Stakeholder Feedback and IESO Response

Market Renewal Program: Engagement session on March 24, 2022

Figure 1

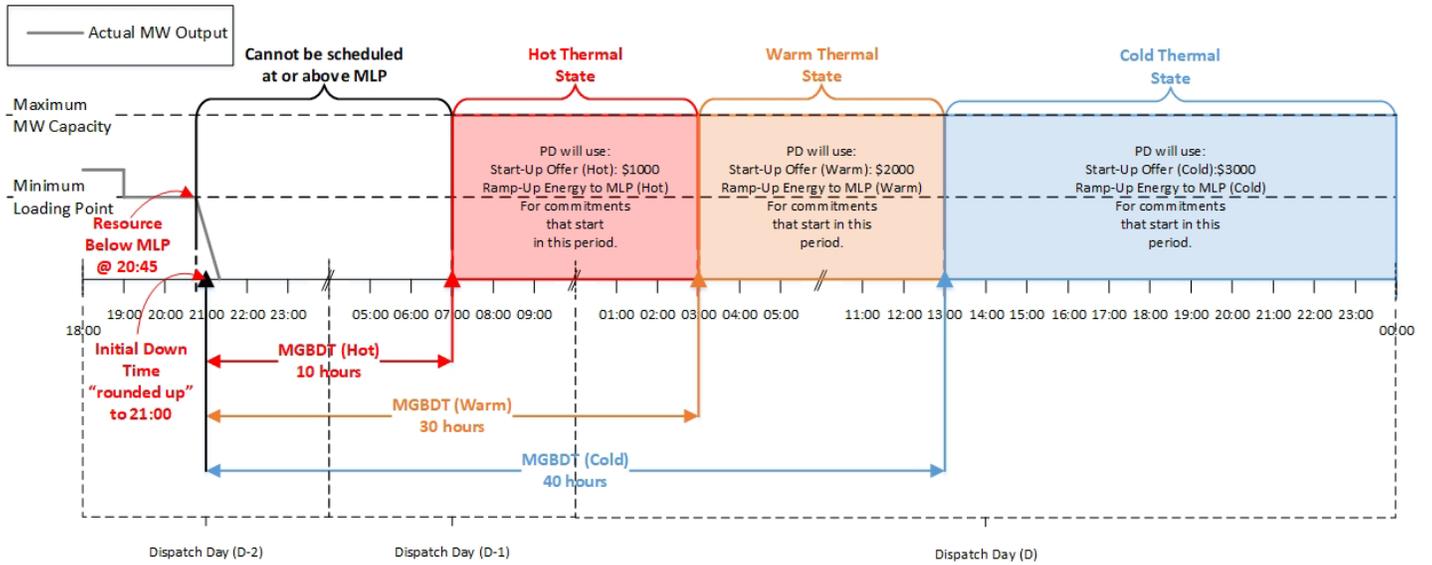
5. For the following example, please provide a graphic similar to slide 20 of the presentation to show how the PD calculation engine infers the thermal state and calculate the appropriate start-up offers:

- A resource was scheduled below minimum loading point (MLP) two days before the current dispatch day (D-2) in HE21, it was dispatched below MLP at 20:45 and was offline with breaker open at 21:20 (HE22);
- The resource remained offline for D-1;
- MGBDT (hot) = 10 h, MGBDT (warm) = 30 h, MGBDT (cold) = 40 h;
- Start-up offer (hot) = \$1000, Start-up offer (warm) = \$2000, and Start-up offer (cold) = \$3000 submitted for all hours;

For dispatch day (D), please depict in graphical form which hours are defined as hot, warm, and cold.

5. [Figure 1](#) in the appendix shows the inferred thermal state to be used by the PD calculation engine based on the example provided and summarized below:

- The example assumes that the resource's actual output dropped below MLP at 20:45 on dispatch day D-2. Because MGBDT is measured at an hourly granularity, the PD engine will "round up" to the start of HE 22 (21:00) on dispatch day D-2 when determining the initial down time of the resource.

- Given MGBDT (Hot) = 10 hours: 10 hours after the initial down time of HE 22 (21:00) on dispatch day D-2, the start of the resource's hot thermal state is HE 8 (07:00) on dispatch day D-1.

- Given MGBDT (Warm) = 30 hours: 30 hours after the initial down time of HE 22 (21:00) on dispatch day D-2, the end of the hot thermal state and the start of the warm thermal state is HE 4 (03:00) on dispatch day D.

- Given MGBDT (Cold) = 40 hours: 40 hours after the initial down time of HE 22 (21:00) on dispatch day D-2, the end of the warm thermal state and the start of the cold thermal state is HE 14 (13:00) on dispatch day D.

Figure 2

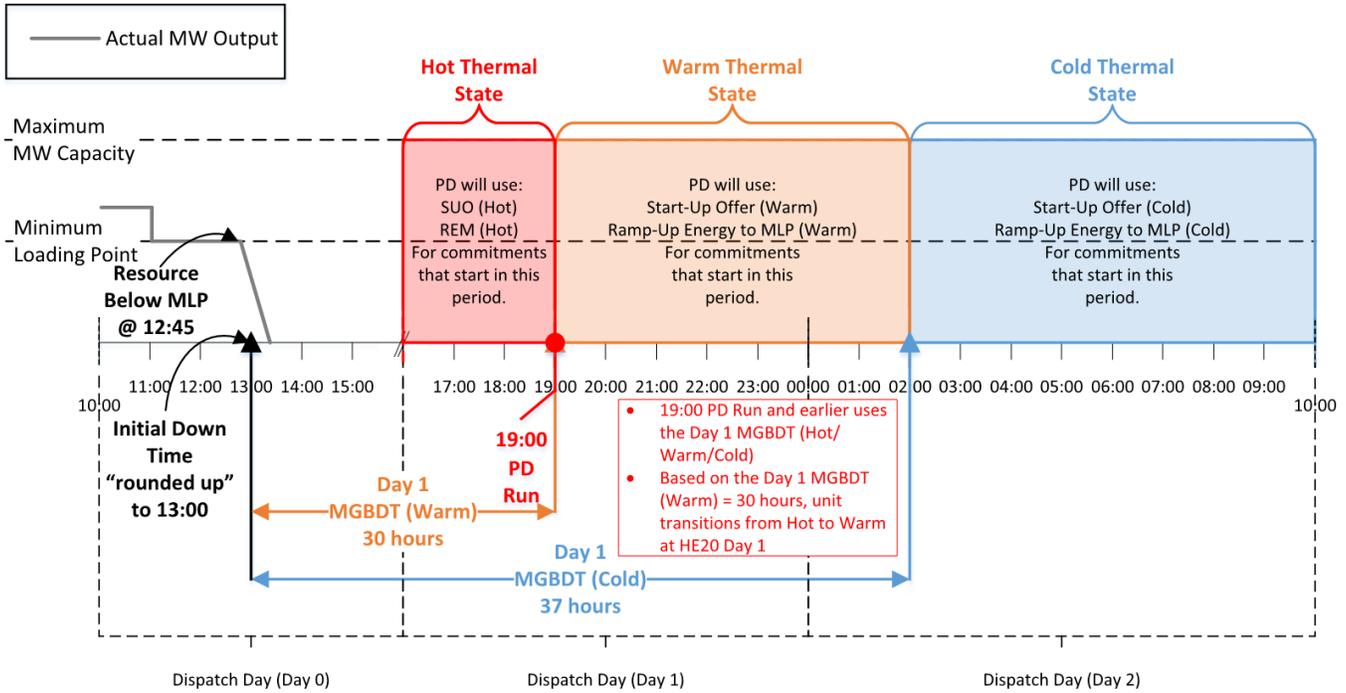
1. Please provide details on how the PD calculation engine assigns the thermal state of a unit based on offers submitted, particularly for instances where a unit's thermal state straddles HE24 of a given day or spans a period of multiple days.

- For example, a unit is at MGBDT (warm) at HE20 of the dispatch day and will stay at MGBDT (warm) until HE3 of the next day. Day 1 MGBDT (warm) = 30 hours and Day 2 MGBDT (warm) = 32 hours. At what time would the unit transition between the two thermal state offers?

1. Section 3.5.5 of the Pre-Dispatch Calculation Engine Detailed Design document v2.0 (pages 73-75) describes how daily dispatch data parameters are treated when the pre-dispatch look-ahead period spans two dispatch days. Specifically, for MGBDT, hourly PD runs starting at 00:00 to 19:00 inclusive on Day 1 will use MGBDT values submitted for Day 1. Hourly PD runs starting at 20:00 to 23:00 inclusive on Day 1 will use MGBDT values submitted for Day 2.

- [Figure 2](#) in the appendix: The warm thermal state transition occurring at 19:00 (Day 1) that would apply to Day 0 PD runs from 20:00 to 23:00 and to Day 1 PD runs from 00:00 to 19:00. While the cold thermal state transition is shown starting in 02:00 (Day 2), this was included for illustration, but would not be included in look-ahead period of the noted PD Runs.
- [Figure 3](#) in the appendix: The updated warm thermal state transition occurring at 21:00 (Day 1) and the unchanged cold thermal state transition occurring at 02:00 (Day 2) that would apply starting with the Day 1 PD run at 20:00.
